November 21, 2014

These comments are submitted on behalf of the Center for Biological Diversity (“Center”) and the Napa Group Sierra Club (collectively “conservation groups”) on the Draft Environmental Impact Report (“DEIR”) for the proposed Walt Ranch vineyard development project (“Project”). The DEIR fails to adequately analyze a range of environmental impacts, mitigation measures, and alternatives. At a minimum, the DEIR must be revised and recirculated to remedy these deficiencies. The Project must also be revised to resolve its conflicts with the County of Napa General Plan, failure to comply with the California Environmental Quality Act (CEQA) as well as the California Endangered Species Act (CESA).

Figure 1 – Ideal Wildlife Friendly Fence

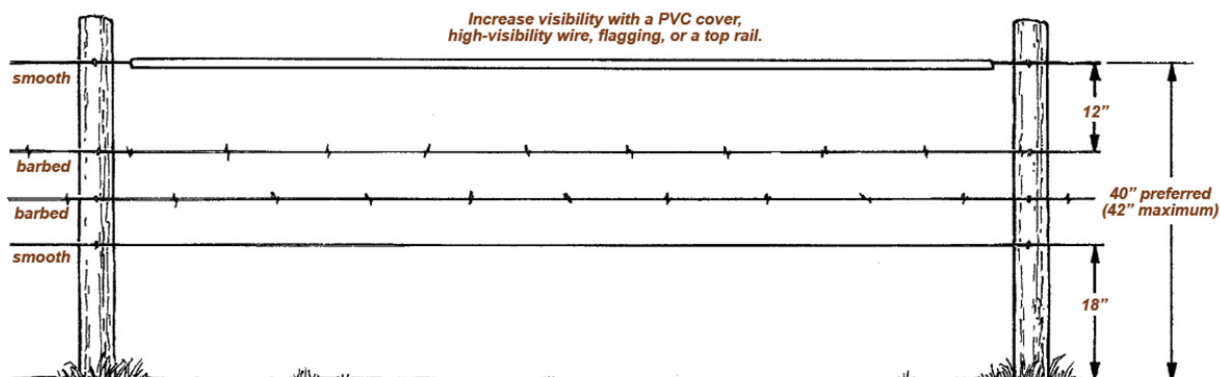
The DEIR recognizes that “deer fencing *may not be necessary*” in some areas, but declines to set any hard limits on how much fencing the applicant can put up. (*Id.* at 4.2-34.) The whole point of exclusionary fencing is to “reduc[e] wildlife movement.” (Napa County General Plan CON-29 (discussing Policy CON-18).) Yet, the DEIR provides no analysis on whether exclusionary fencing is necessary in the first place. (*See* DEIR at 4.2-99 – 4.2-101.) This initial analysis is necessary to productively evaluate the value of added fencing against the cost of this fencing to species mobility.

Because death is, by any measure, a significant “reduction of wildlife movement,” the conservation groups request that the County take this threat seriously and in accordance with Napa County’s General Plan Policies. (Napa County General Plan CON-29 (discussing Policy CON-18).) Therefore, the conservation groups asks that the County either entirely prohibit the planned fencing at Walt Ranch, or, at a minimum, require the Applicant to only install ecologically friendly fencing to the extent that prohibiting fencing is infeasible.

Figure 2: Contra Costa goldfields habitat overlaid with a map of Walt Ranch

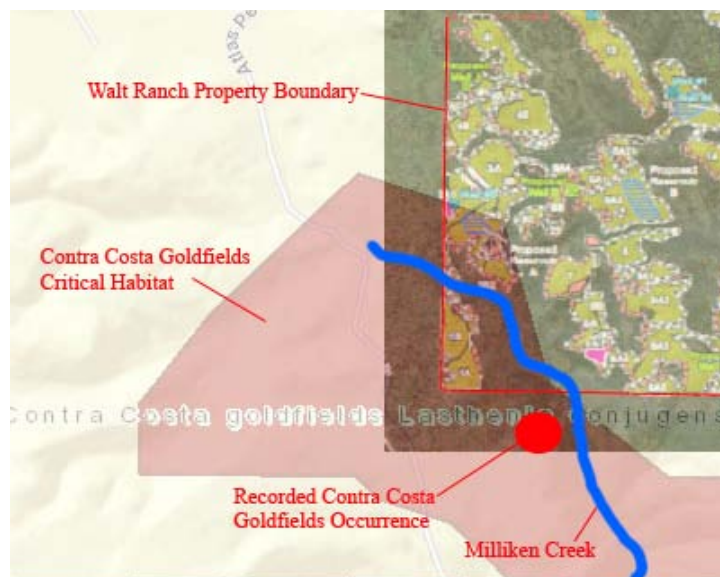
The DEIR recognizes that goldfields habitat was present at Walt Ranch, but fails to mention goldfields critical habitat either within or surrounding Walt Ranch. (See DEIR 4.2-31, 4.2-47.) The DEIR also does not address the recorded goldfields present immediately South of Walt Ranch. (*Id.*; Fig. 2, *supra.*) Milliken Creek runs through Walt Ranch and then continues directly into the goldfields' critical habitat and through the area where goldfields have been located. (See Fig. 2, *supra.*)

To set an acceptable baseline against which to measure the Project's impacts, Napa County needs to discuss the goldfields' critical habitat both on and near Walt Ranch. (CEQA Guidelines § 15125(a).) Because the County has failed to provide an adequate baseline, its nonexistent discussion of impact significance also fails the standards set by CEQA. (*Woodward Park Homeowners Assn, Inc. v. City of Fresno* (2007) 150 Cal.App.4th 683, 687; CEQA Guidelines § 15125(a) & (e).) In the next draft of the EIR, the County should discuss potential impacts to on-site goldfields critical habitat and the potential for negative downstream effects of continued vineyard operations at Walt Ranch. The County should also mandate mitigation for these effects so that they are below a significant level. (CEQA Guidelines §§ 15126, 15126.6.) Specifically, we request that all proposed vineyard plots within or near the goldfields' critical habitat not be developed, and that all potential goldfields habitat on-site be improved and set aside for conservation. Also, the County should prohibit all herbicide use that may wash or drift into Milliken Creek or other parts of the goldfields' critical habitat. The next draft of the EIR should also discuss any additional federal permits the Applicant needs to develop on the goldfield's critical habitat, such as a federal ITP. The County should also discuss whether Section 7 ESA consultation is required for the County to approve the Applicant's erosion control permit.
